Submit 1 Copy To Appropriate District		•	Farme C 102
Office	State of New Mexico Energy, Minerals and Natural Resources OIL CONSERVATION DIVISION 1220 South St. Francis Dr. Santa Fe, NM 87505		Form C-103 Revised July 18, 2013
<u>District 1</u> – (575) 393-6161 1625 N. French Dr., Hobbs, NM 88240			WELL API NO.
<u>District II</u> – (575) 748-1283 811 S. First St., Artesia, NM 88210			30-015-32320     5. Indicate Type of Lease
<u>District III</u> – (505) 334-6178 1000 Rio Brazos Rd., Aztec, NM 87410			STATE X FEE
<u>District IV</u> – (505) 476-3460 1220 S. St. Francis Dr., Santa Fe, NM 87505			6. State Oil & Gas Lease No.
SUNDRY NOT (DO NOT USE THIS FORM FOR PROPO	ICES AND REPORTS ON WELLS SALS TO DRILL OR TO DEEPEN OR PLU CATION FOR PERMIT" (FORM C-101) FO		7. Lease Name or Unit Agreement Name CLYDE
PROPOSALS.) 1. Type of Well: Oil Well X	Gas Well Other		8. Well Number ,

## **CONDITIONS OF APPROVAL FOR PLUGGING & ABANDONMENT**

Operator:_	Chouron	
Well Name	& Number: Clyde 1	
API #:	30-015-32320

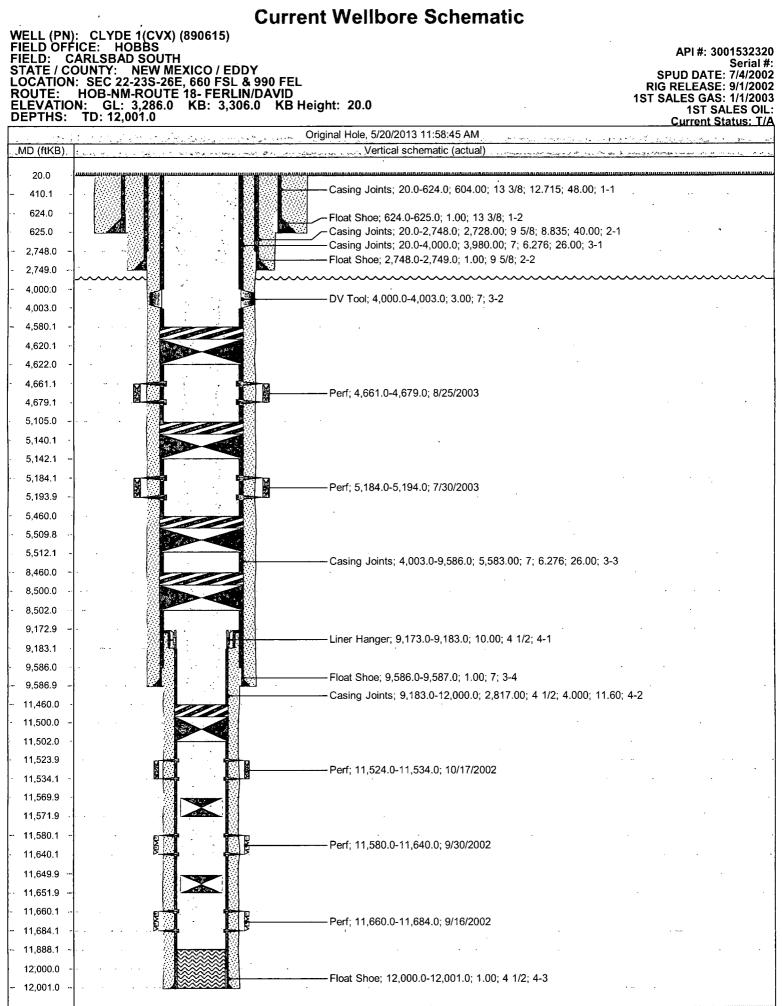
- 1. Produced water <u>will not</u> be used during any part of the plugging & abandonment operation.
- 2. Notify NMOCD Dist. 2 office at least 24 hrs before beginning work.

- **3.** Closed Loop System is to be used for entire plugging operation. Upon completion, contents of steel pit are to be hauled to a permitted disposal location.

- 7. Every attempt must be made to clean the well bore out to below the perfs, before any plugs can be set, by whatever means possible.
- 8. Cement Retainers may not be used.

- 9. Squeeze pressures are not to exceed 500 PSI, unless approval is given by NMOCD.

10. Plugs may be combined after consulting with and getting approval from NMOCD. 11. Minimum WOC time for tag plugs will be 4 Hrs.
